NP-11-0025
June 17, 2011

Subject: Exelon Nuclear Texas Holdings, LLC
Victoria County Station Early Site Permit Application
Response to Request for Additional Information Letter No. 07
NRC Docket No. 52-042

RAI 02.05.02-6c:**Question:**

Figure 1. Site Amplifications at GMRS horizons for 10^{-4} LF Input Motion

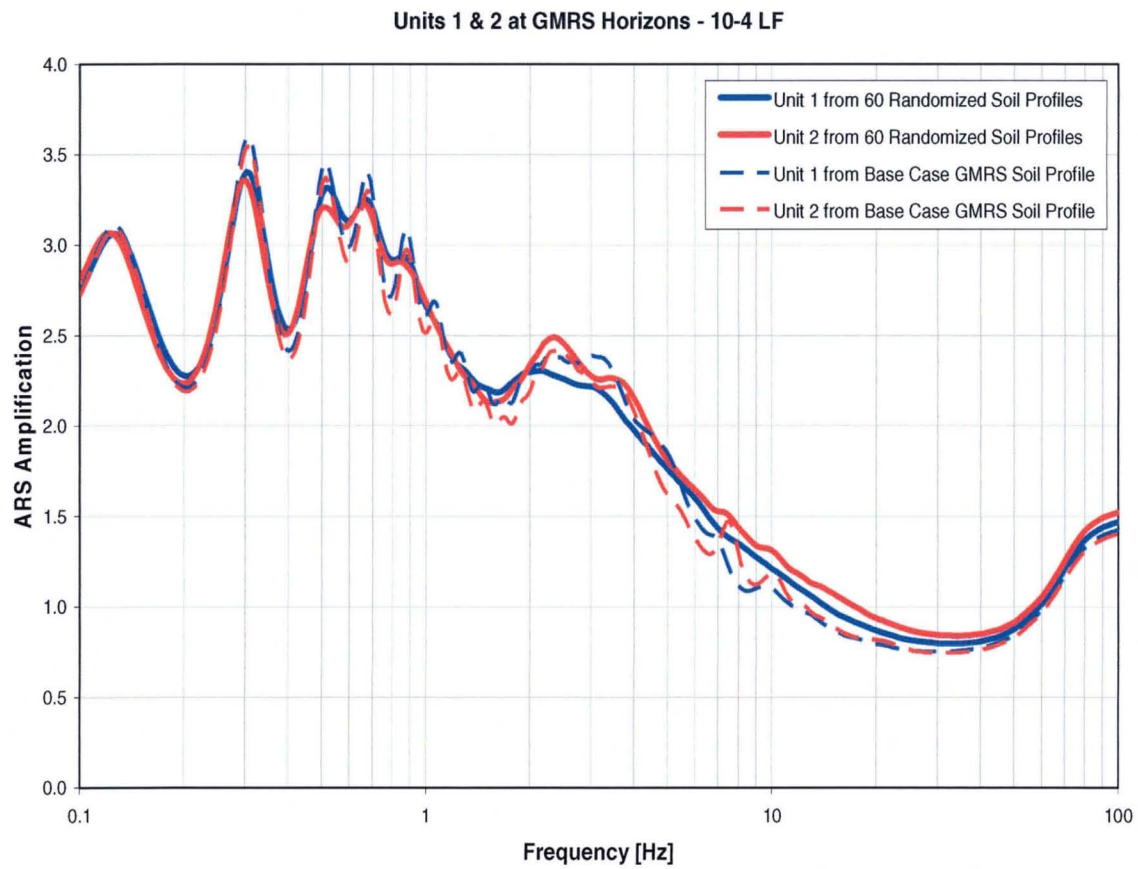
- c) Please describe the resonant features shown in SSAR Figures 2.5.2-58, -63, and -68 and whether they result from the truncated soil column used by the applicant to model the site's seismic-wave transmission.

In response to this RAI, a new set of limited site response analyses was performed using the base case soil columns with best estimate soil properties for each unit and LF and HF rock input motions at the 10^{-4} and 10^{-5} hazard levels. The site amplification factor results from the new limited site response analyses are plotted in Figure 1 through Figure 4. For comparison purpose, the corresponding log-mean site amplification factors calculated using the randomized soil profiles (SSAR Figures 2.5.2-58, -63, -68, and -73) are also plotted in the figures. As shown in all four figures, the site amplification factors calculated using the base case soil columns are very similar and close to the log-mean site amplification factors calculated using the randomized soil profiles. Of interest is that the peaks of the site amplifications occur at about the same frequencies for all four input rock motions (LF and HF at 10^{-4} and 10^{-5} hazard levels) at both locations (Units 1 and 2). Because the base case soil columns effectively replicate the site amplification characteristics as represented by the mean response of the randomized profiles, it is reasonable to use the base case soil columns, in lieu of the randomized profiles, to develop the response to address this RAI question. In addition, due to similar nature of the soil amplifications in terms of peaks and valleys for the HF and LF input motions at both hazard levels and the similar responses from the two locations, Units 1

and 2, the results of the base case soil column for Unit 1 for the 10^{-4} LF input motion are used to extract additional responses as described below.

The resonant features associated with the first four peaks of the site amplification factors below a frequency of 0.7 Hz are evaluated by examining transfer functions between various horizons using the base case soil column of Unit 1 with the 10^{-4} LF input motion. The frequency domain harmonic transfer function between the top of the soil column (GMRS horizon) and rock input motion (outcrop at 8016 ft depth from the GMRS horizon of Unit 1) shows the first peak at a frequency of about 0.12 Hz. This is about the same frequency as the first peak of the site amplifications as shown in Figure 1. Therefore, it is concluded that the first peak of the site amplifications is the result of the resonant feature of the entire soil column (8016 ft). Examining the transfer functions from other depths, it is noted that the second, the third and the fourth peaks of the site amplification factors are the resonant features of the top portion with approximate column height of 2016 ft, 816 ft, and 516 ft. This evaluation confirms that due to the stratigraphy of the site with soil layers having contrasting shear wave velocities, the site response includes multiple resonance frequencies each corresponding to a different part of the soil column with higher frequencies controlled by the upper part of the soil column.
